NS9750B-0

Errata

90000530, Rev E

NS9750 Hardware Reference, Rev. C

Hardware workaround:

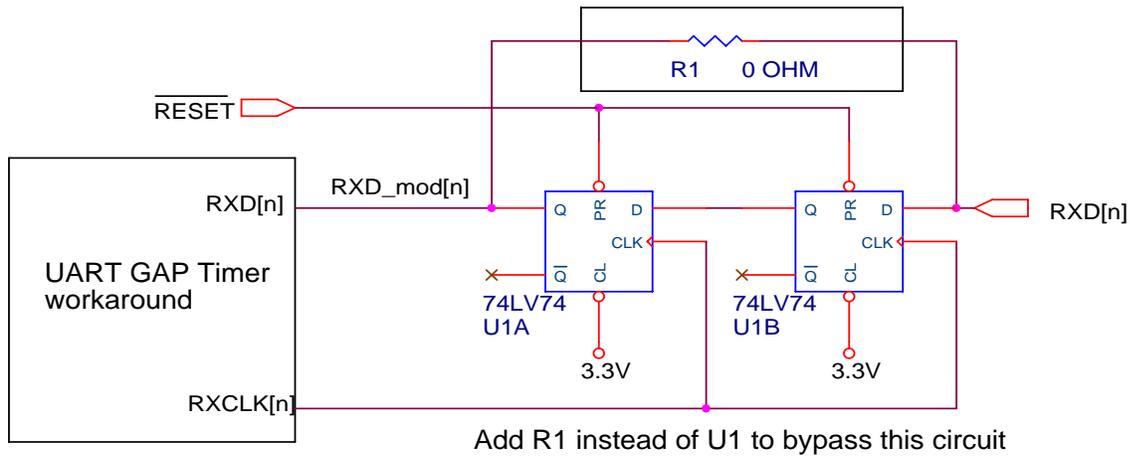
The start bit of a new character may not be detected when the character or buffer gap timer expires. Framing, parity, or data corruption occur when a start bit is missed.

A hardware workaround eliminates the possibility of receiving a start bit when a character or buffer gap timer is expiring. The workaround drives the baud clock off-chip and synchronizes the incoming data with this clock. As a result, the buffer and character gap timers and the next start bit have a fixed and known relationship with each other.

- The TMODE bit in the Bit-rate register must be cleared.
- Baud rates are limited to those available in x16 mode
- Baud rates with a divisor of 0 are not possible for all CPU frequencies. This translates to a maximum baud rate of 460k in x16 mode.
- Baud rates with a divisor of 1 are not possible for CPU frequencies below 147MHz. This translates to a baud rate of 230k in x16 mode.
- The buffer and character gaps must be an even multiple of the sample clock period. For a 96000bps UART in x16 UART mode, the equation is:
- $\text{Timer increment} = ((1/9600) / 16) \times 2 = 13.020\mu\text{s}$
- One GPIO per UART is required to output the baud clock. The baud clock can be output on the RI pin on each UART. This function is controlled by the RXEXT bit (27) in each Serial Bit-rate register.

UART CTS-related transmit data errors

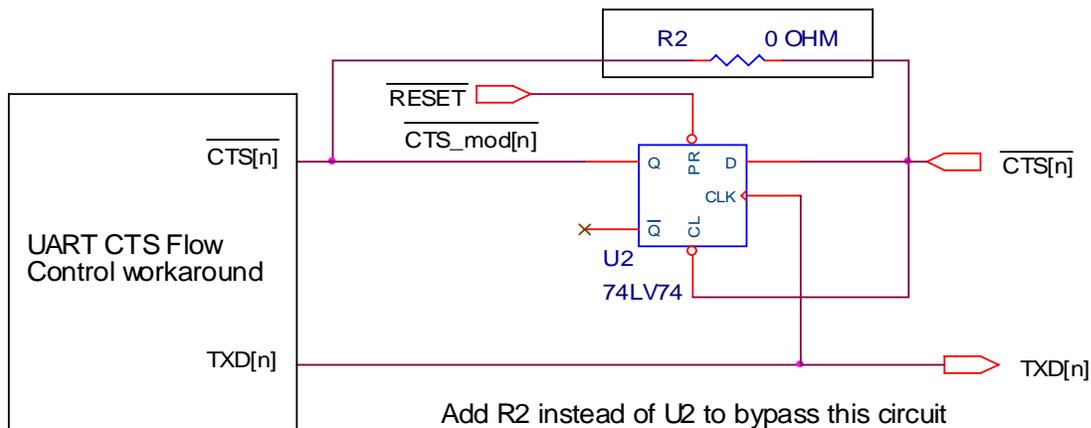
A problem occurs when the CTS flow control signal is de-asserted during the BCLK that begins processing a new character. This problem causes the previous character to be re-transmitted instead of getting the next character from the transmit FIFO.

Hardware workaround: For each UART, externally clock the CTS signal with the Txd_n signal to guarantee that CTS will not be seen de-asserting at the start of a character.

This drawing shows a recommended logic workaround:

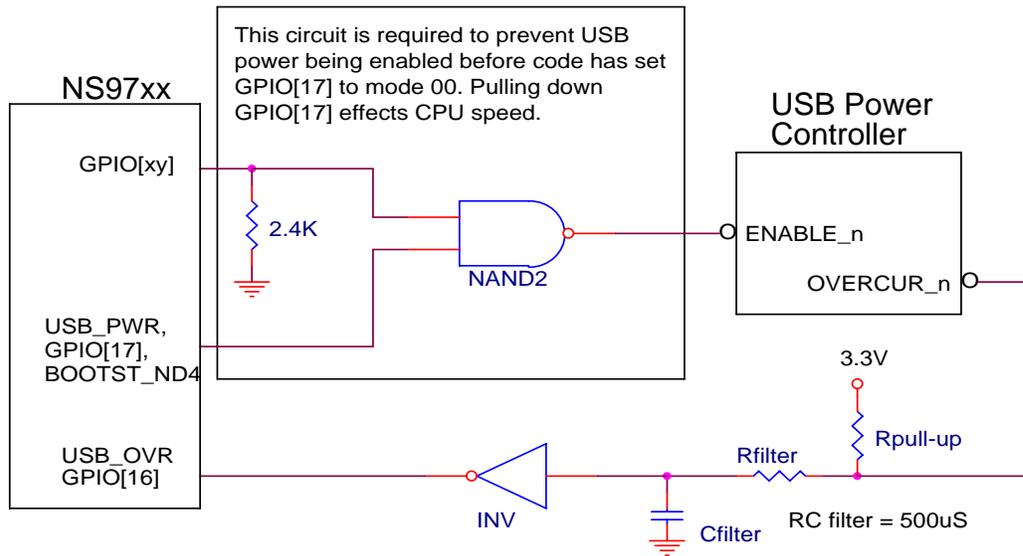
The USB PWR (power) control output requires additional external logic and GPIO to prevent USB power from being enabled from the time power is valid until the code has set the USB registers and selected gpio[17] to mode 00. The polarity of USB PWR is true high. Pulling down GPIO[17] to disable the USB power control changes the CPU bus speed because this pin is also bootstrap – ND4.

Designs that add the additional GPIO to prevent USB power-on during startup would require the BSP, as a final step, to set this GPIO to output a 1.
